## **BID ADDENDUM NO. 3**

### **Johnson Student Center**

### **Building Demolition, Increment 1 (Demolition) and Increment 2**

RANCHO SANTIAGO COMMUNITY COLLEGE DISTRICT  
SANTA ANA, CA

**PERSPECTIVE VIEW** SCALE NTS

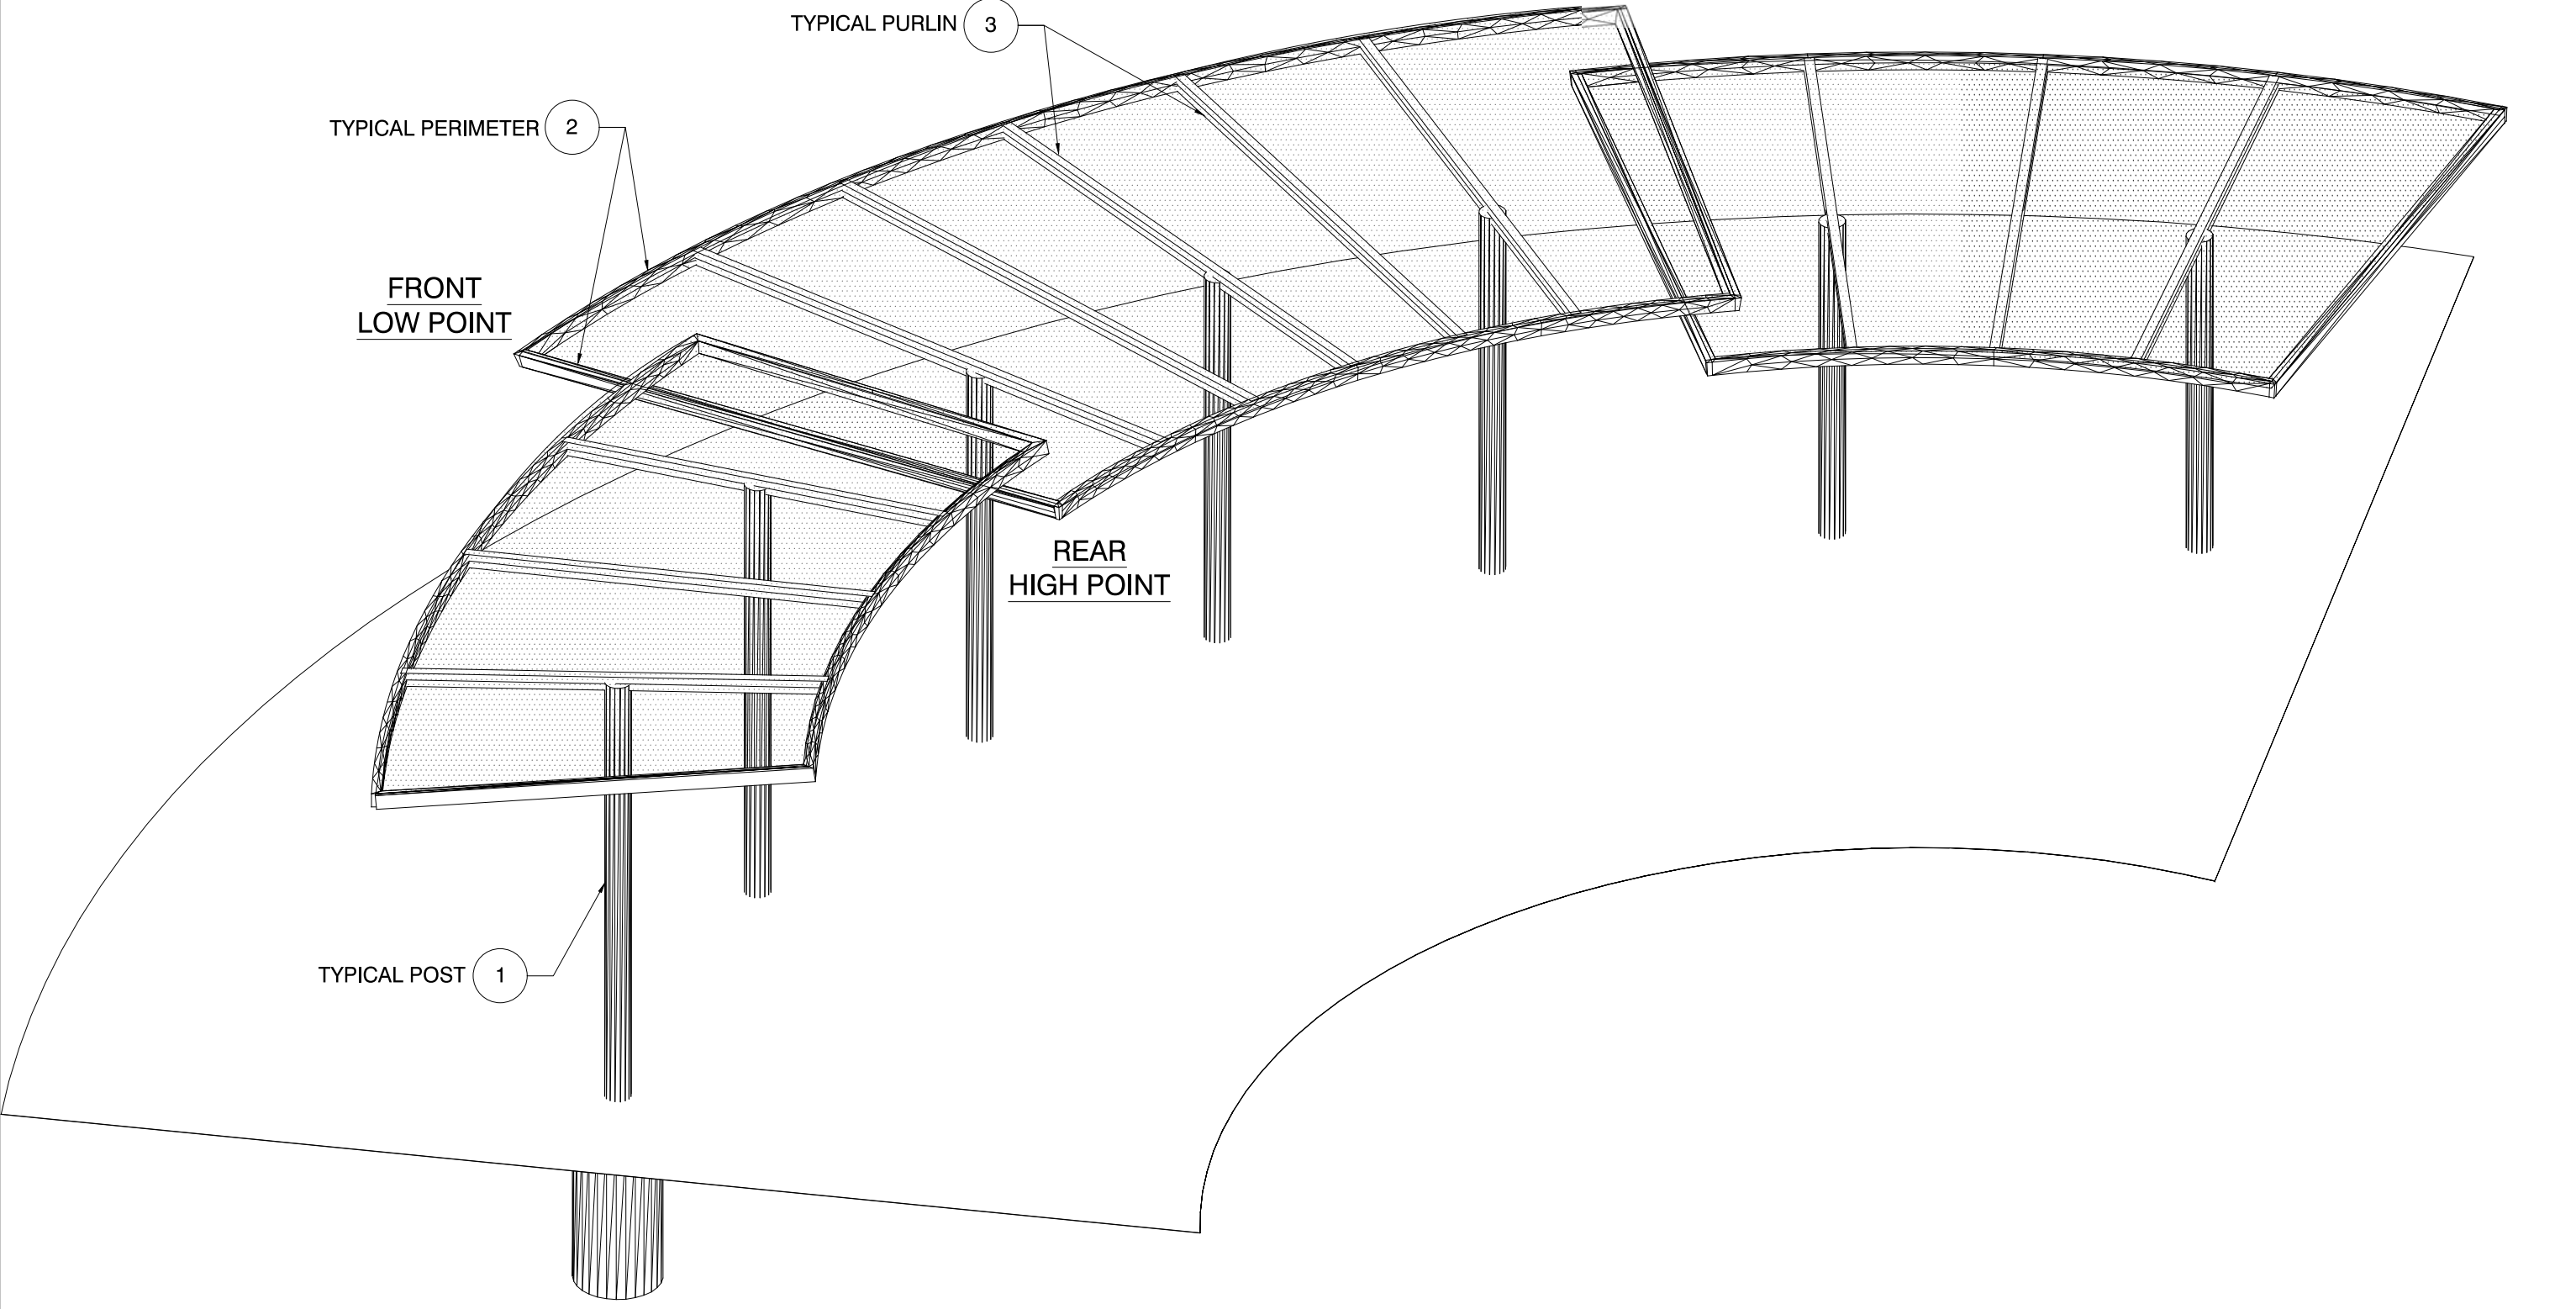
- Increment 2
  - Revised sheet SS1.02.1
    - Detail call out on SS1.02.1 Rear Elevation referenced F/A1.03 for the shade footing, this call out was revised to F/SS1.03.

DATE:	09/18/2018		
FROM:	S.Monsen - McCarthy	EMAIL:	SMonsen@McCarthy.com
SPECIFICATION NUMBER:		DRAWING NUMBER:	SS1.02.1
REQUESTED CLARIFICATION:			
Increment #2 - Sheet SS1.02.1 - Rear Elevation - The reference call out to Detail F/A1.03 for the Shade footing should be Detail A/SS1.03 instead.			
RESPONSE TO CLARIFICATION, <b>SUBMITTED AS PART OF AN ADDENDUM:</b>			
<b>MHP Response: 9/19/2018</b> <b>Sheet SS1.02.1 - Rear Elevation - The reference call out Detail F/A1.03 for the shade footing should be Detail F/SS1.03</b> <b>-AE</b>			
RESPONSE PROVIDED BY:	<b>Adam Egan / MHP</b>	DATE:	<b>09/24/18</b>

**P2.12**

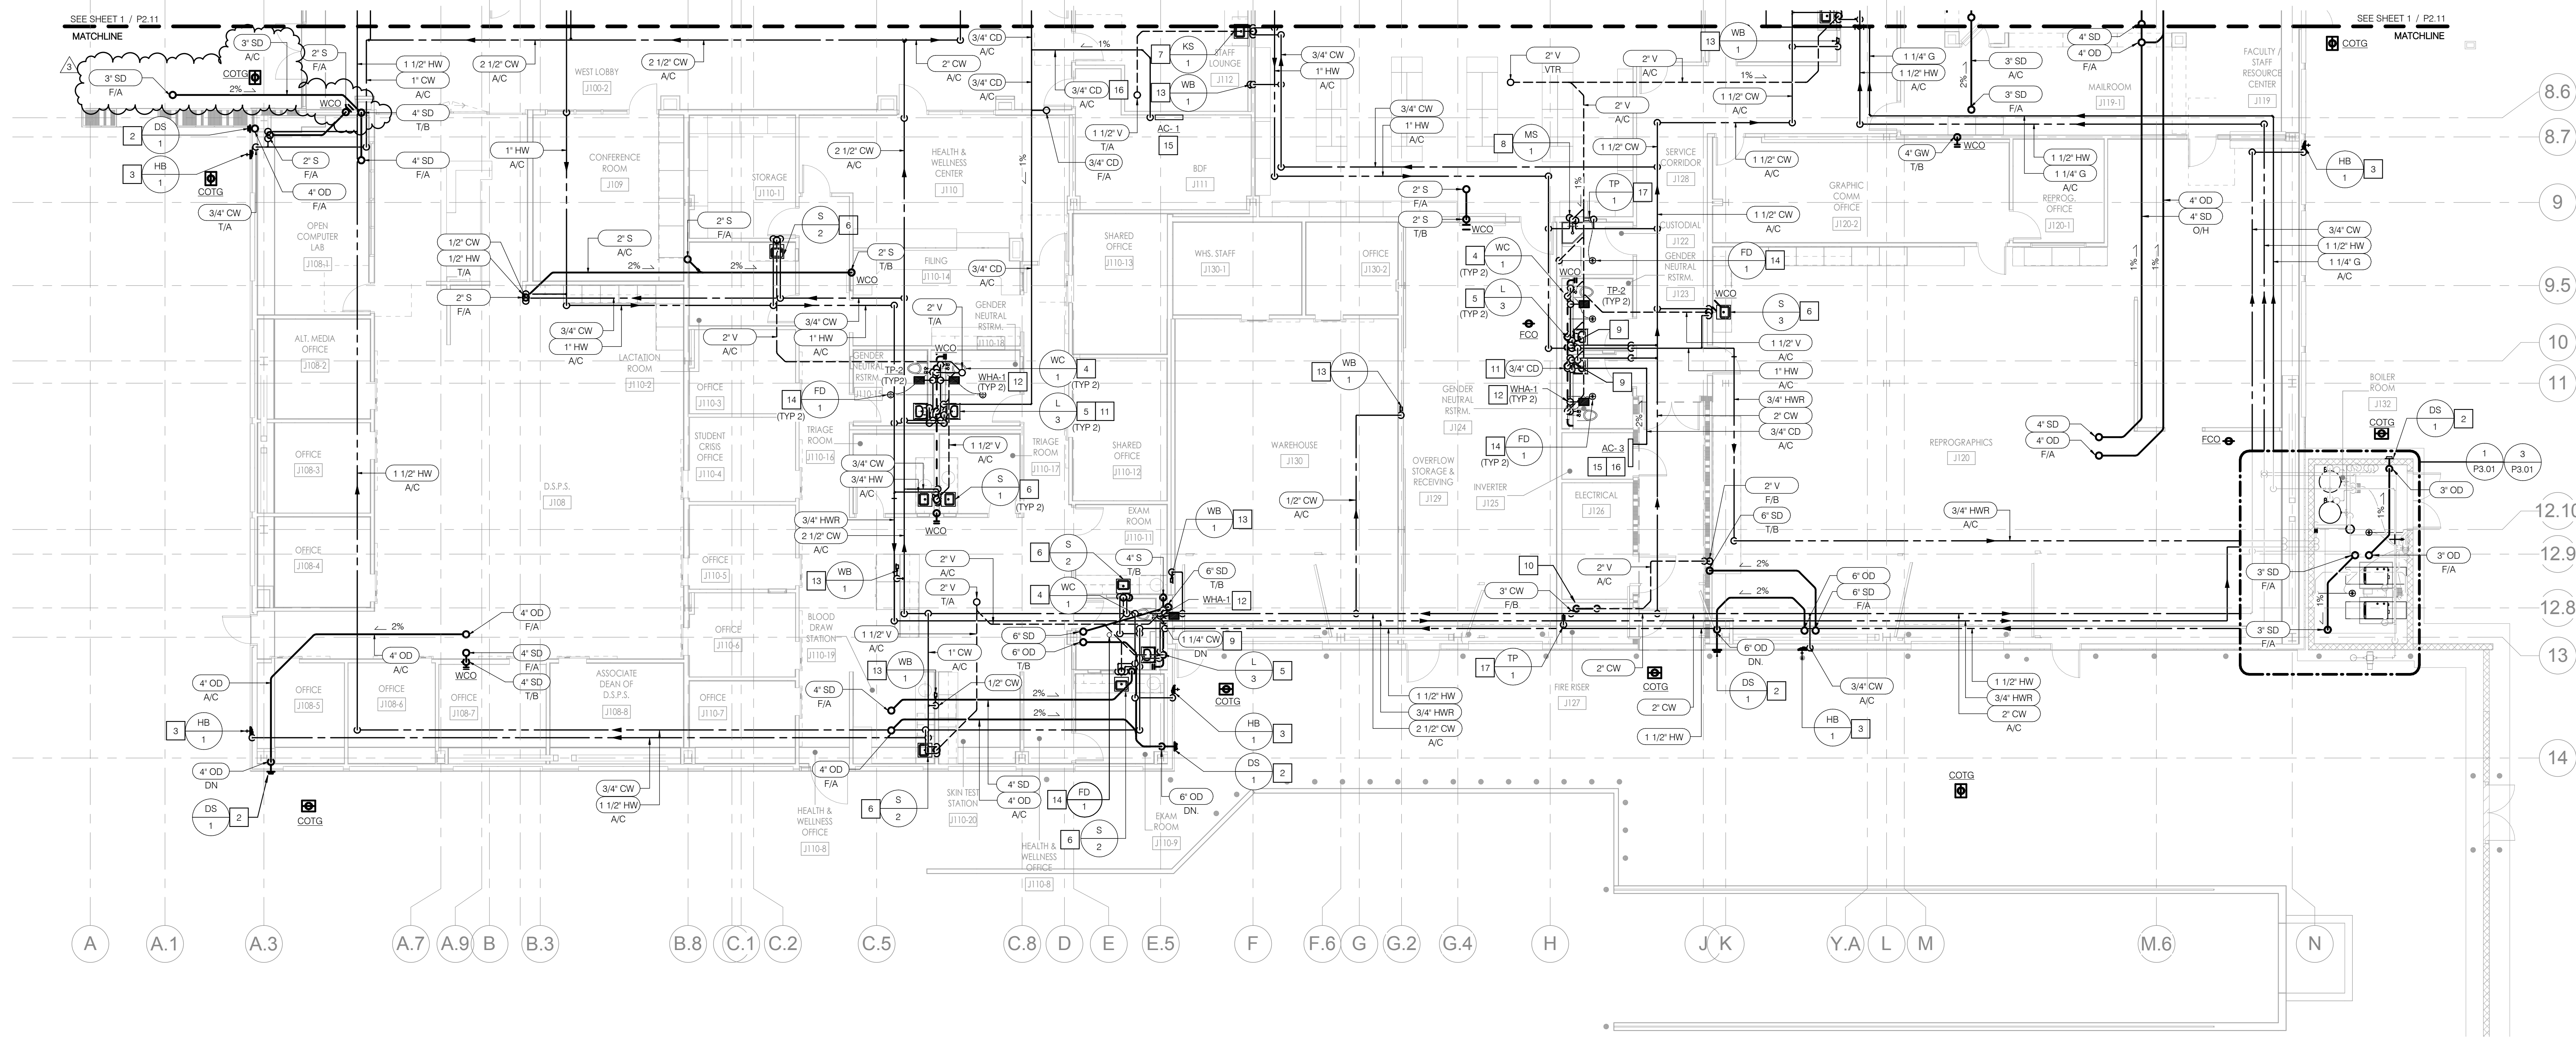
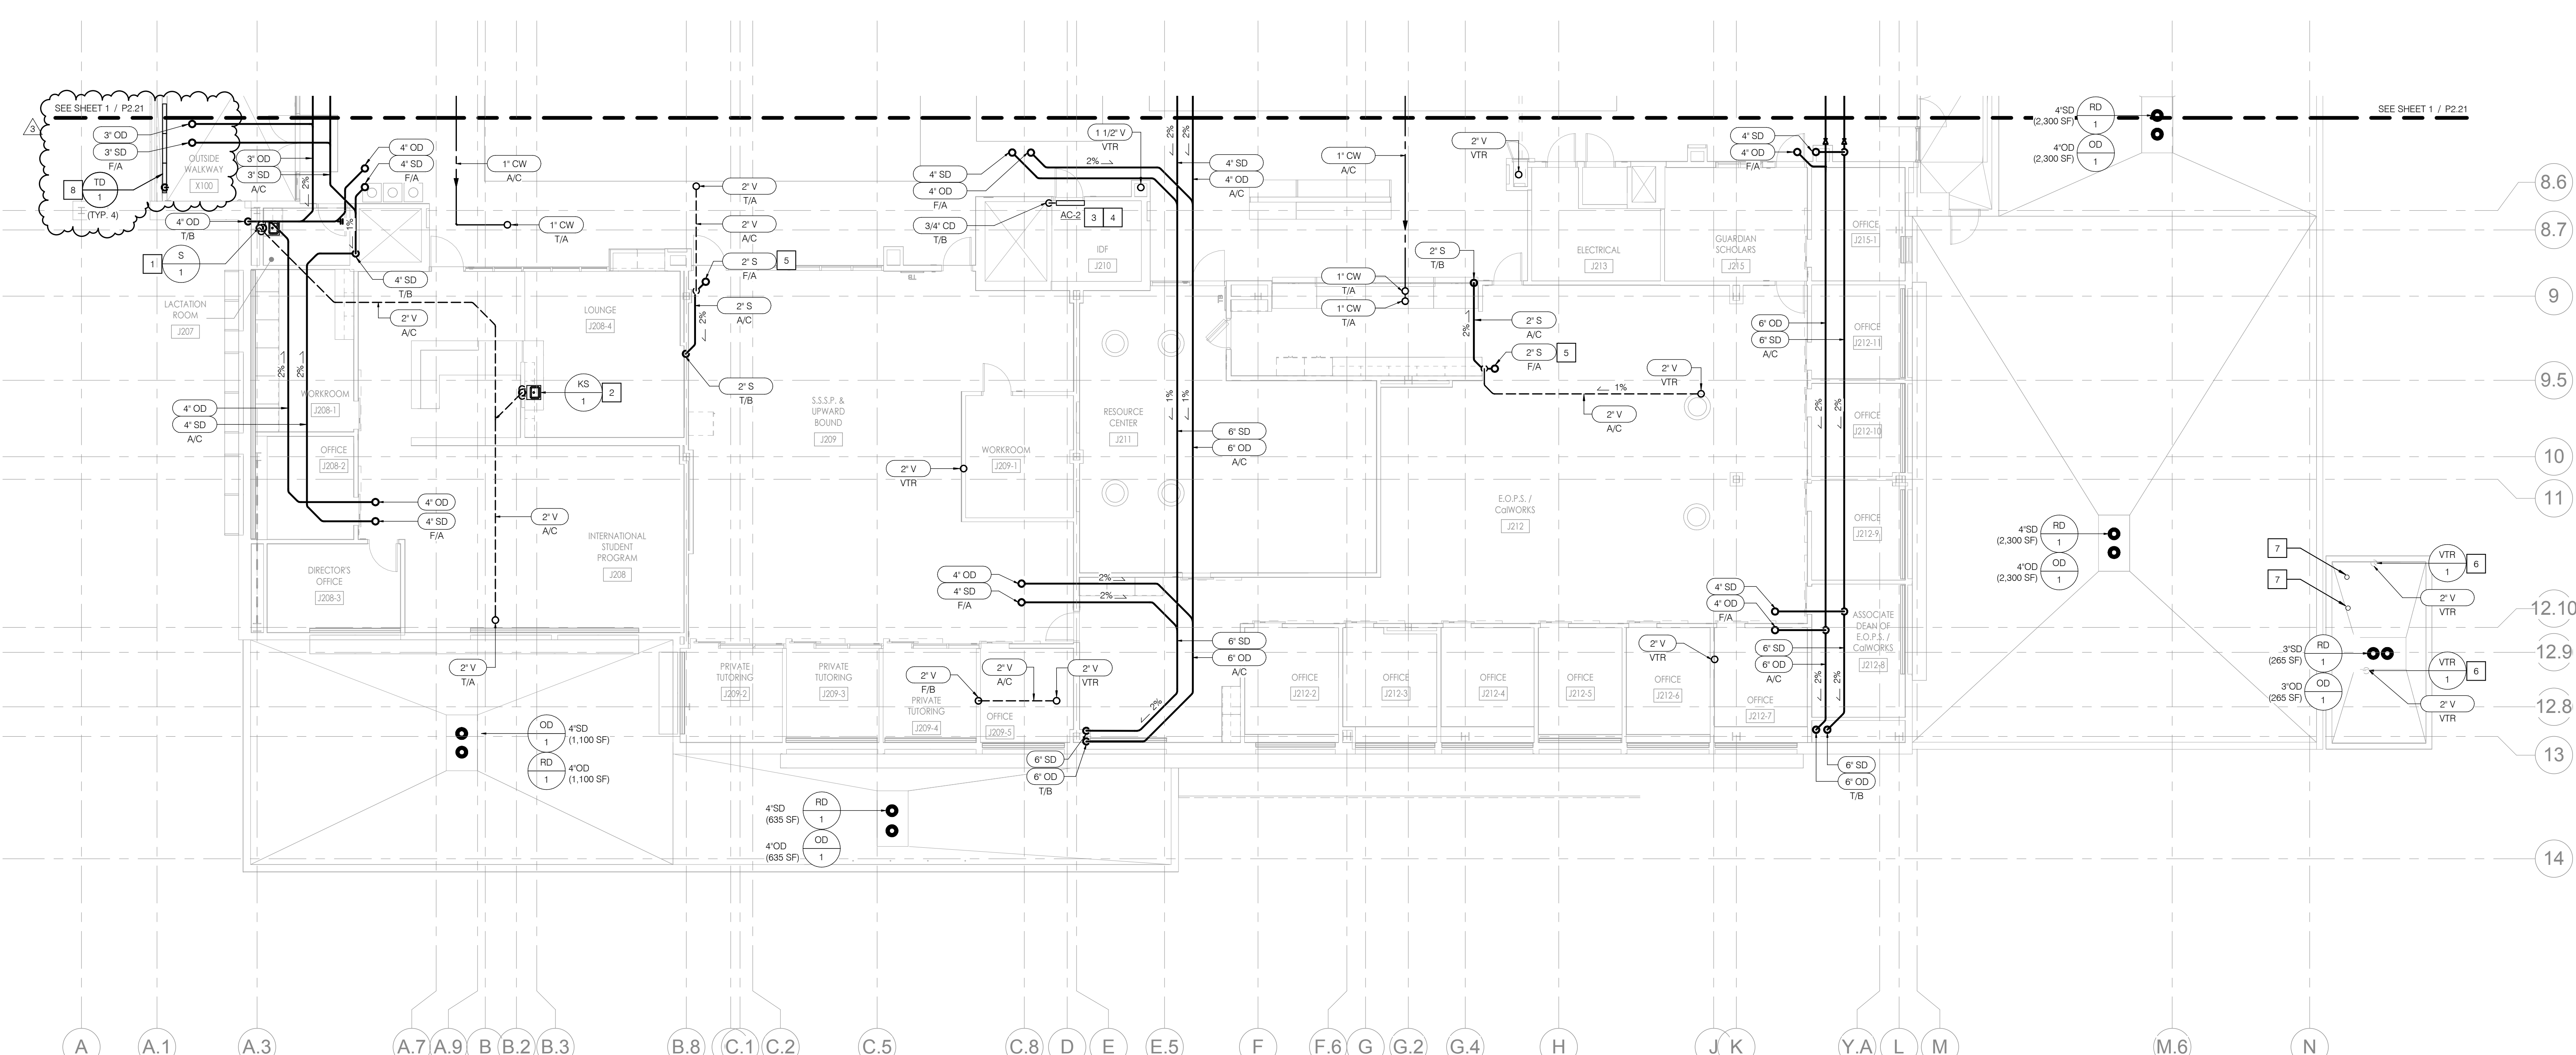
- Increment 2
  - i. P2.12 added trench drain at Stair 1
  - ii. P2.22 added trench drain at Stair 1

- PROVIDE TRENCH DRAIN CHANNELS AT EDGE OF BALCONY. COORDINATE EXACT LENGTH WITH ARCHITECTURAL DRAWING 13/A6.10. REFER TO P2.12 FOR DRAIN OUTLET LOCATIONS FROM DRAIN CHANNELS.
